ADDENDUM NO. 3

DATE: March 13, 2020

OWNER: Howard County Public School System

PROJECT: Hammond High School Renovation and Addition
Columbia, Maryland
Architect Project No. 18011

7 CAFETERIA EQUIPMENT CABINET
SCALE: NONE

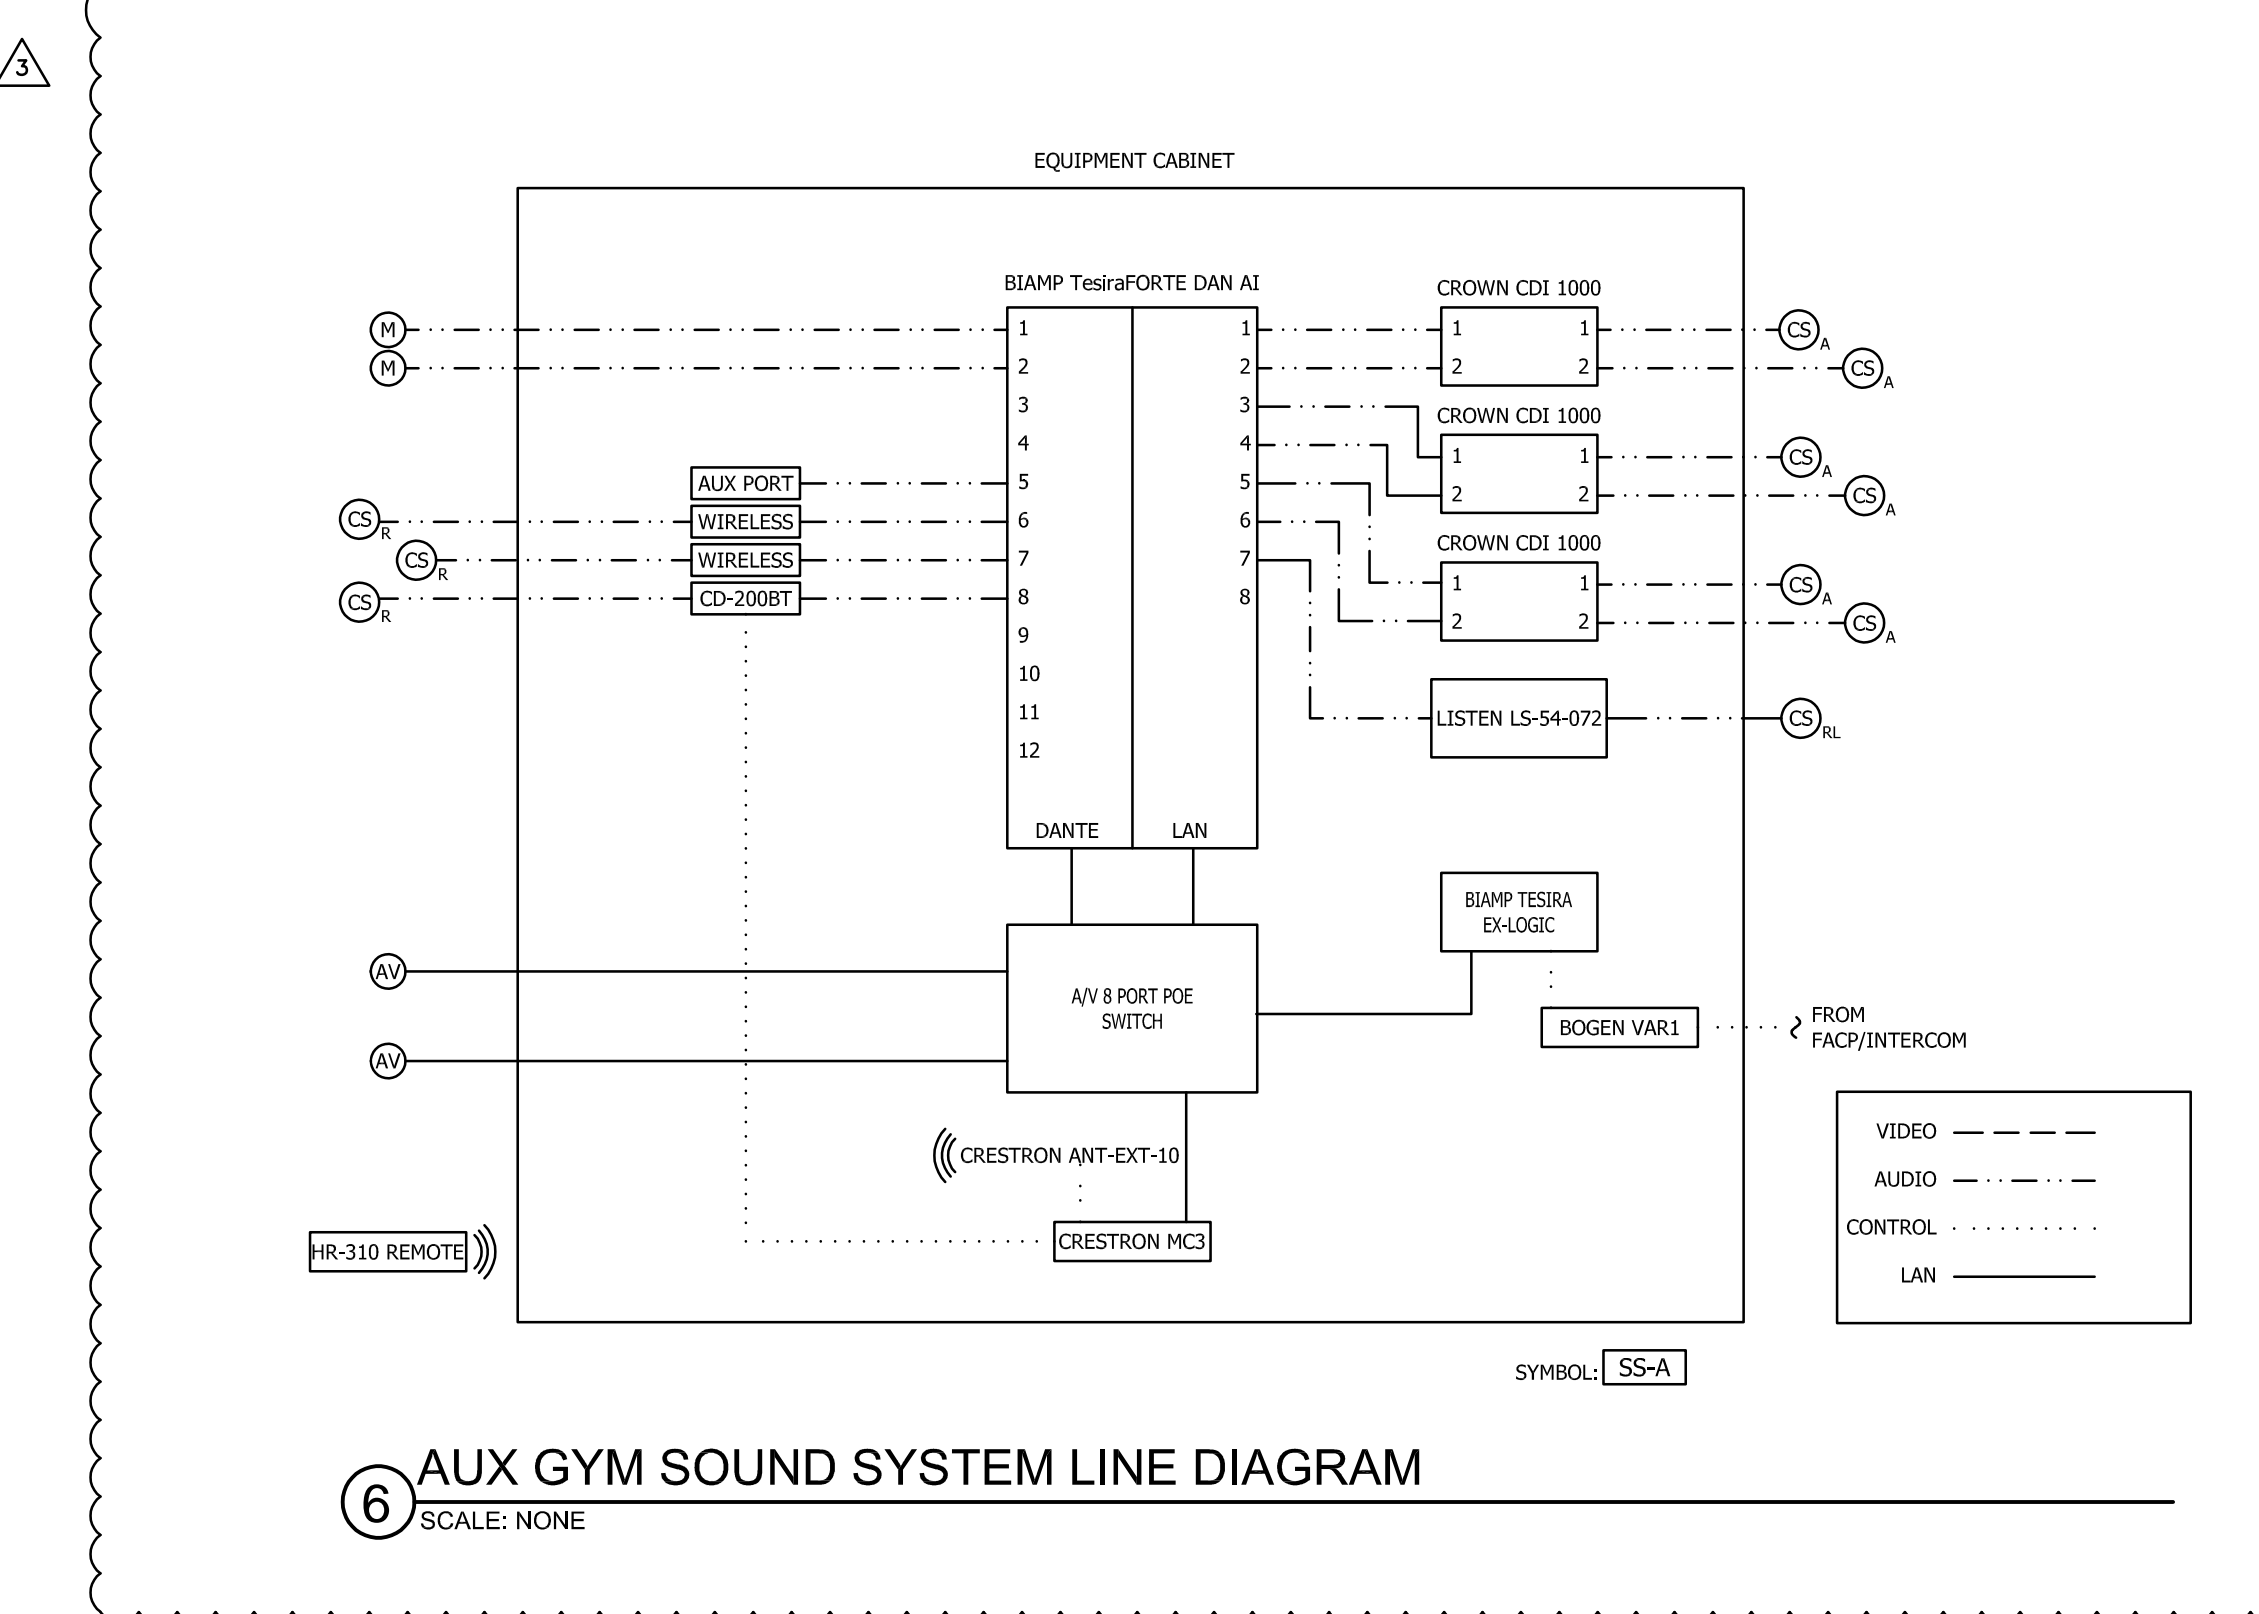
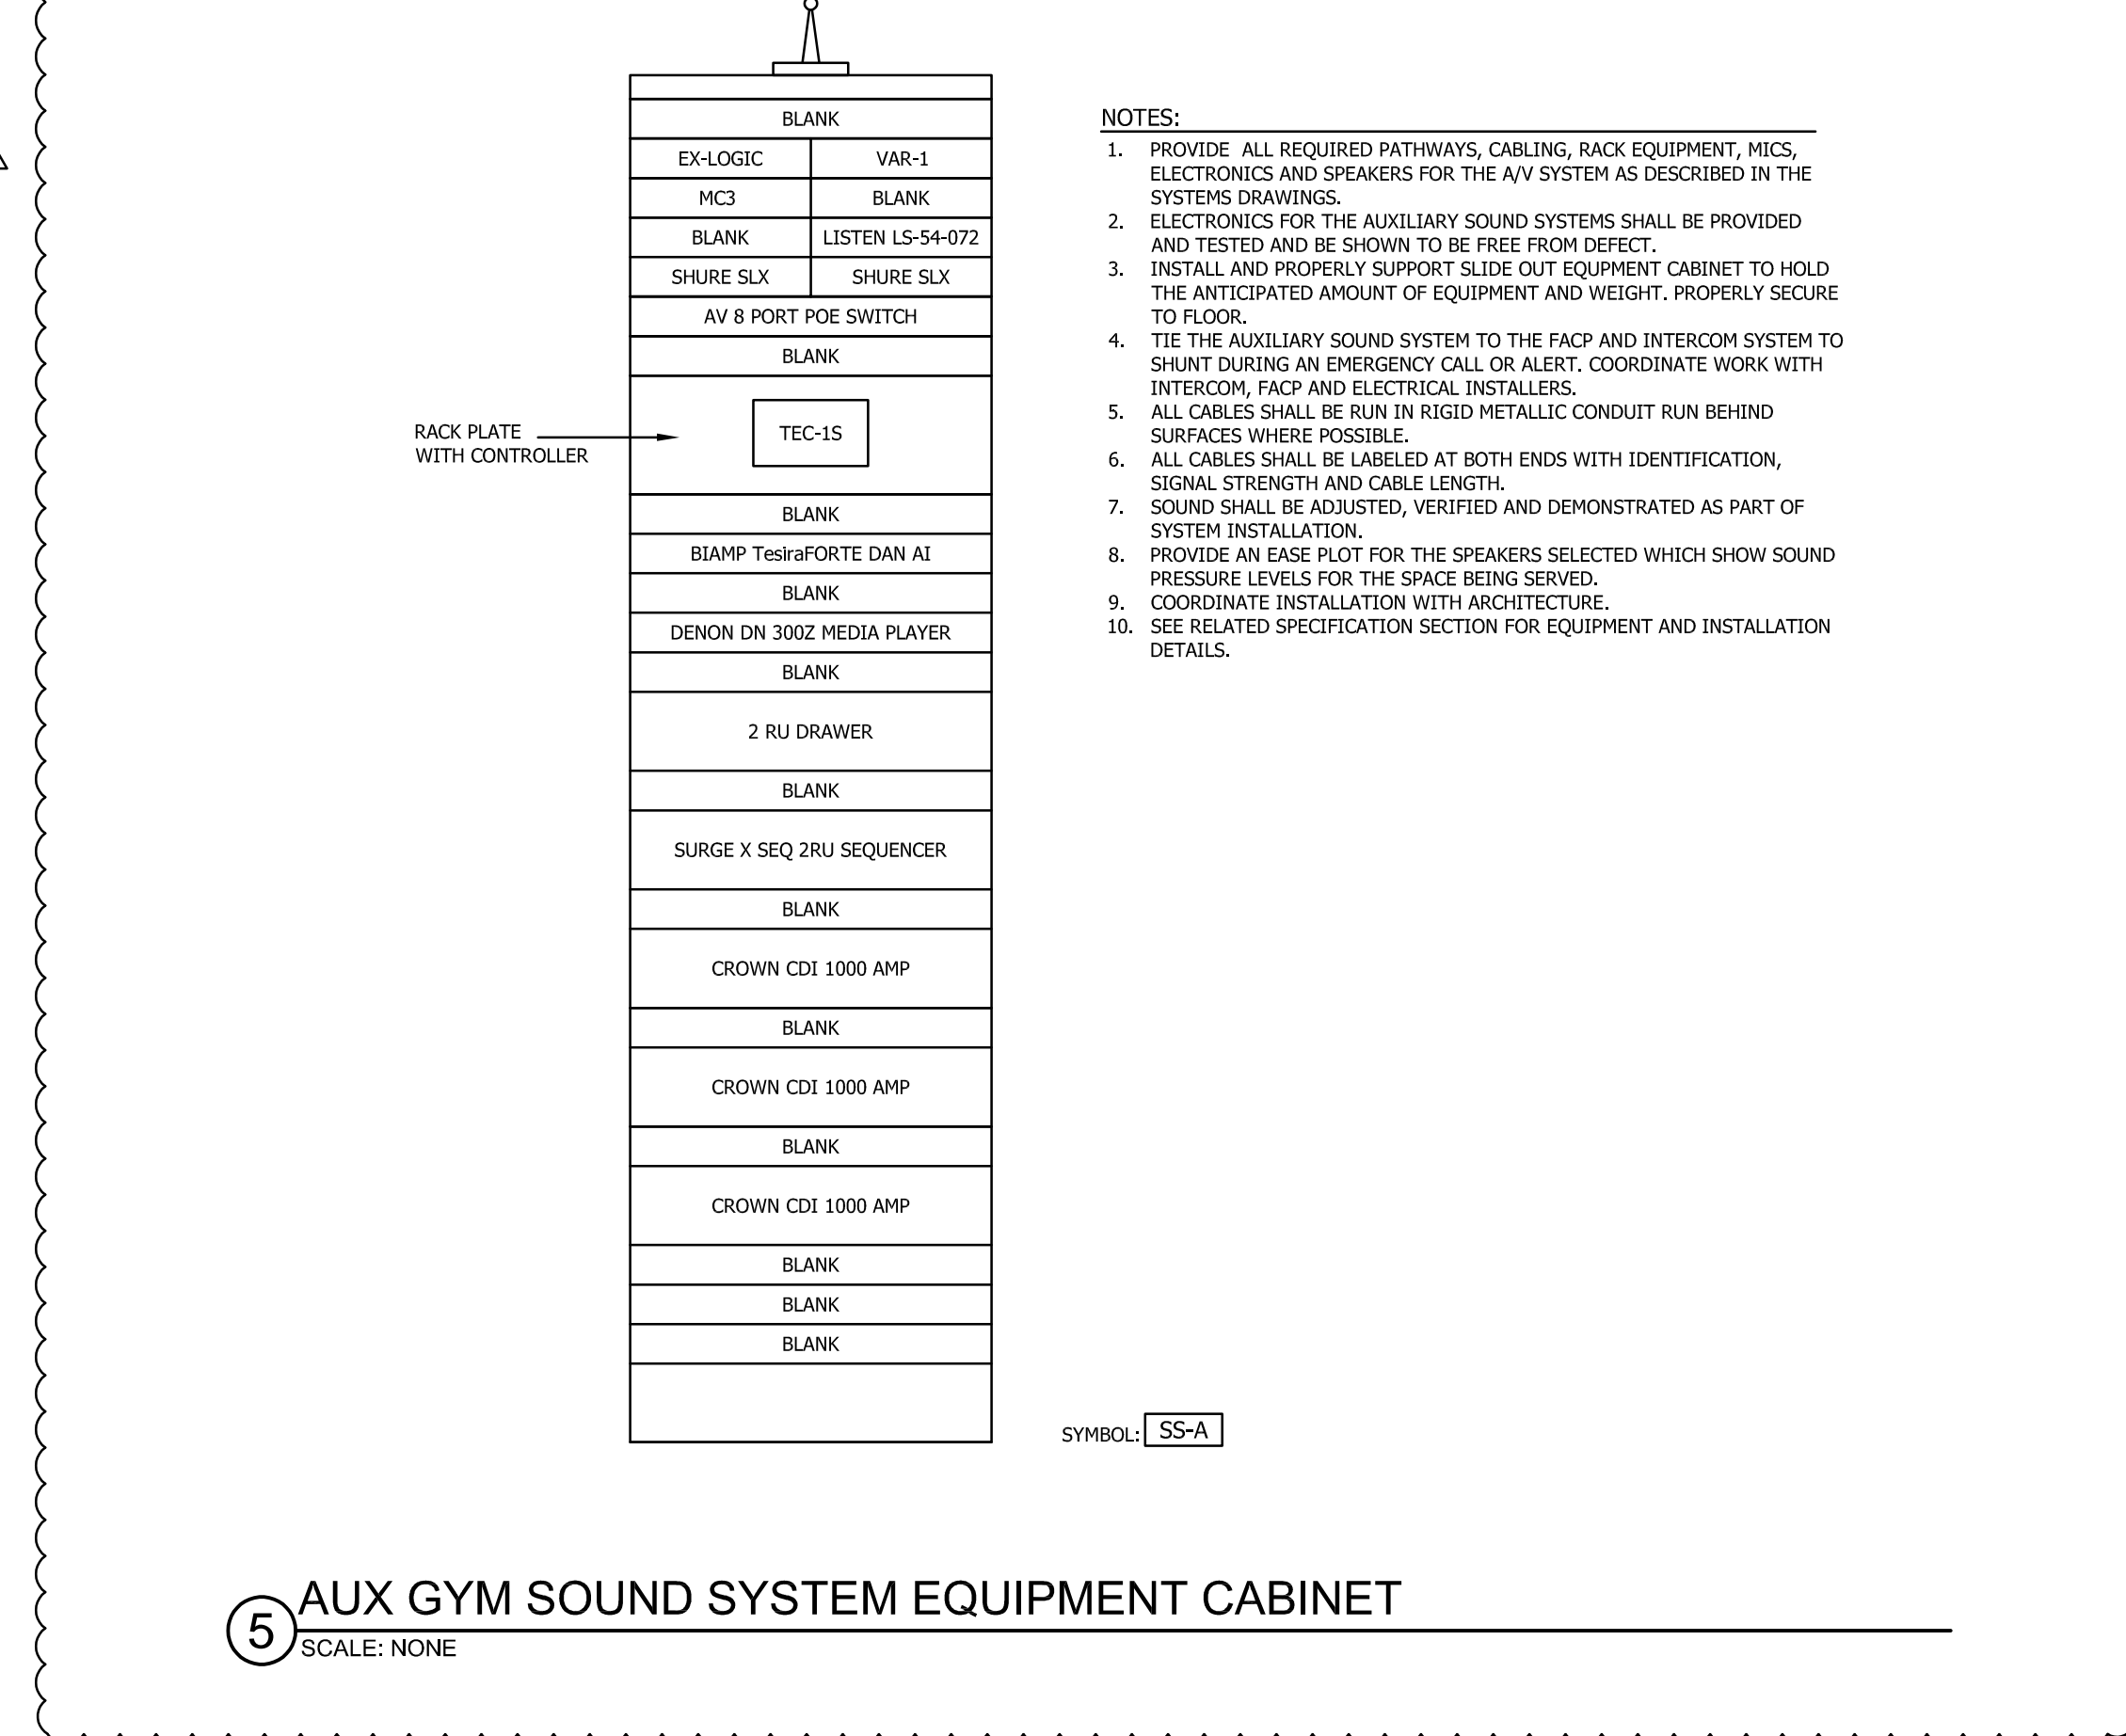
- 27L. Cafeteria/Aux Gym: Drawing E7.05 does not include provisions for the wired microphone wall plates located in these spaces

- 27M. The ceiling speaker coverage in the cafeteria shown using Sound Enhancement speakers may be insufficient in noisy environments. (Drawing E4.03)

- Sheet E7.00 – Details – Electrical
 - **REPLACE SHEET** – Revisions to Luminaire schedule.
- Sheet E7.06 – Details – Electrical
 - **REPLACE SHEET** – AV details added.

RESPONSE: Addendum #3 has additional details on sheet E7.06.

RESPONSE: Addendum #3 has additional details on sheet E7.06.

UE2.0

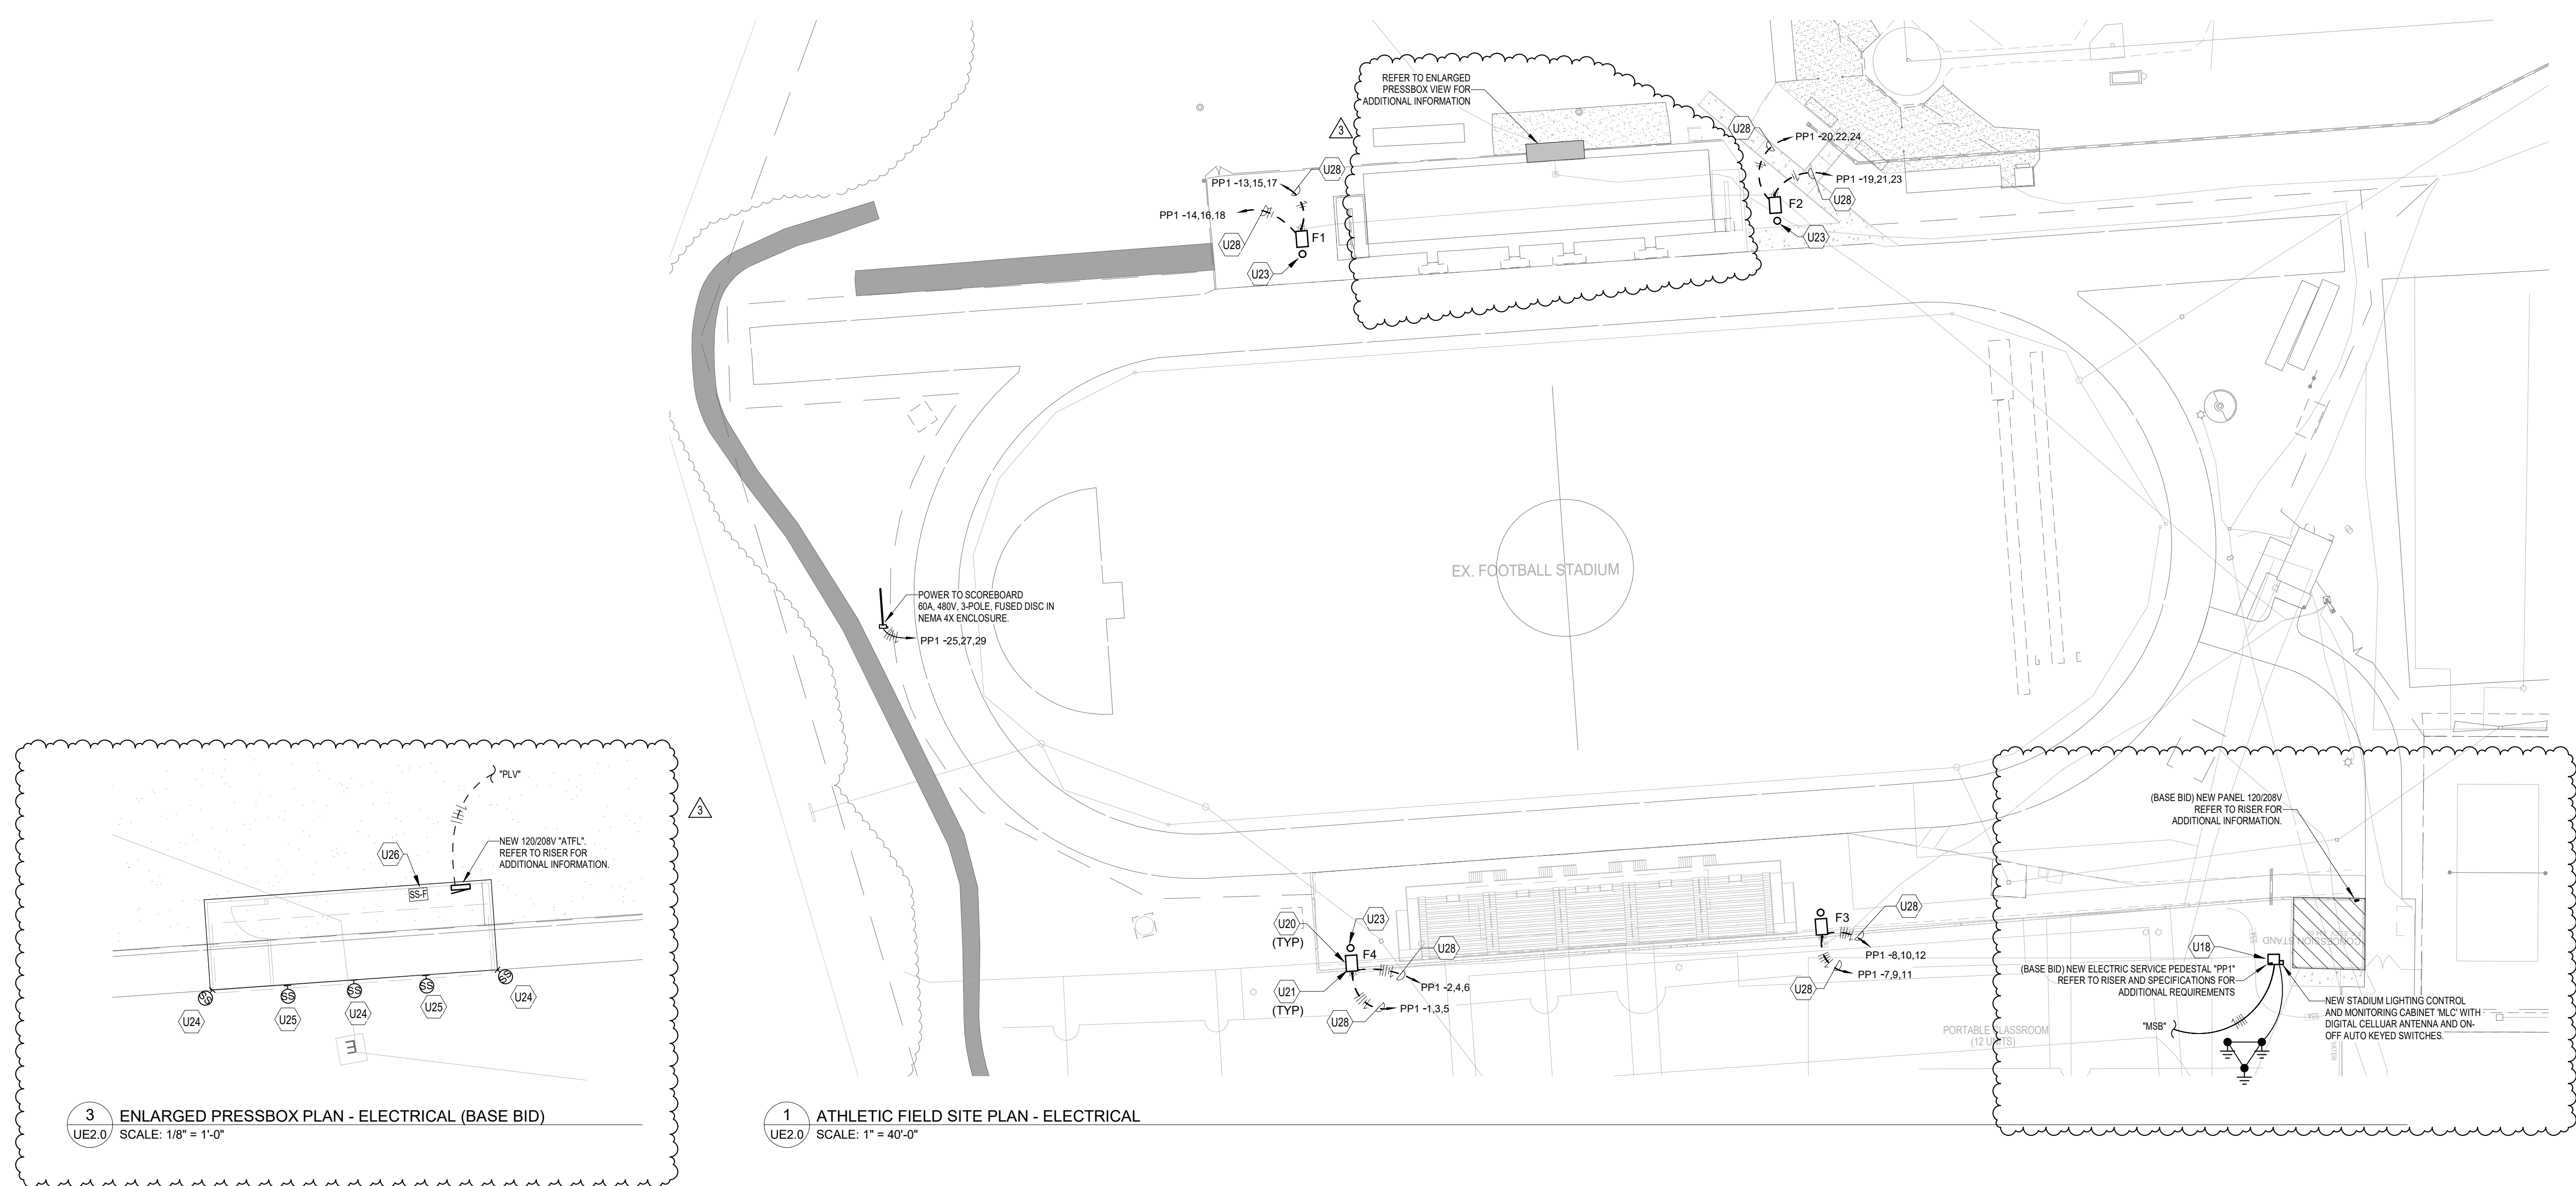
27Q. Stadium: Drawing UE2.0 shows the location of sound system speakers, but did not include elevations, aiming, system schematic or block diagram of the system Please provide the design criteria for the stadium sound system to include the above.

- Sheet UE2.0 – Alternate Site Plan – Electrical
 - **REPLACE SHEET**

RESPONSE: Addendum #3 has additional details on sheet UE2.0.
